Providence City Plan Commission

AGENDA ITEM 1 ■ 116 WATERMAN STREET

OVERVIEW

Proposed floor plans

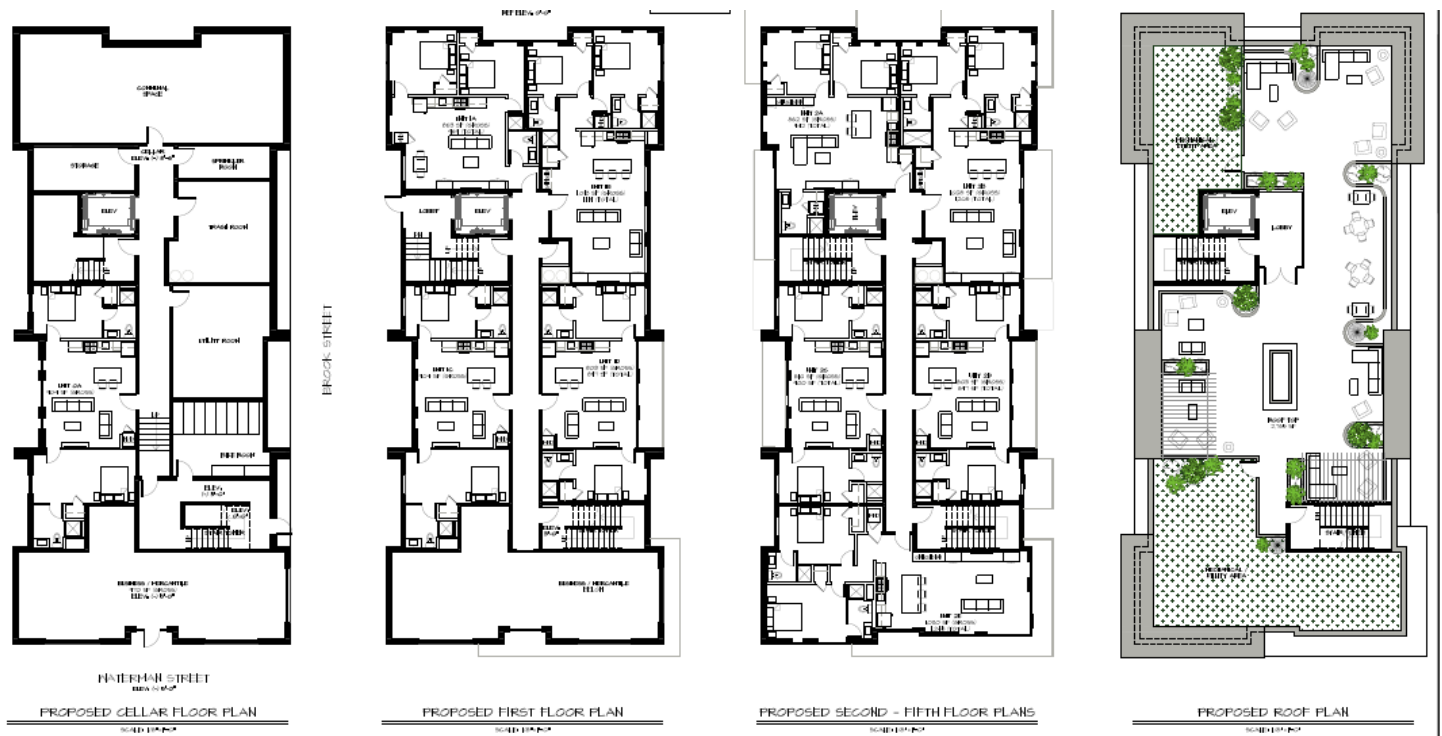
The buildings occupying the lots are proposed to be demolished, and the lots merged. The building will be set to the front, side and rear lot lines, with Waterman Street providing the main entrance to the commercial space. Access for residents, the elevator and the lobby, will be provided from Brook Street. Common space and greenery will be provided at the roof level. The transformer will be located on lot 181, to the west of the development, that is also owned by the applicant.

A dimensional adjustment is being requested for a proposed height of approximately 58' and five stories, which is over the 50' four-story height limit of the zone. Over 60% of the front façade will be located at the front lot line, meeting the design requirement of the zone. The building's exterior will employ stone veneer, wood siding and a composite panel system, which are materials that are permitted by right. The east elevation on Brook Street will primarily feature brick on the ground floor, with the upper stories mainly composed of wood siding with balconies. The transparency on the commercial area will exceed 50% and the upper stories will provide over 10% of required transparency.

The applicant is requesting a design waiver from the requirement that no residential use be located within 20' of a main street as Waterman and Brook Streets are considered main streets. Commercial space for the entire Waterman Street frontage will be provided but the waiver will apply to the Brook Street frontage. Based on plans provided and the site's layout, it would be difficult to situate non-residential use along the length of Brook Street without affecting the building's layout. The ground floor residences will be not be directly at street level as Brook Street slopes upward from south to north and a portion of the Brook Street frontage will be occupied by the commercial space. The façade has varying elements that are in character with the nature of the surroundings. The main residential entrance will be located on Brook Street, which would activate this frontage and provide street activity.

The CPC should grant the dimensional adjustment for a height of 58' and five stories, finding that the applicant will provide vertical mixed use development.

The CPC should grant the design waiver for location of residential use within 20' of a main street.
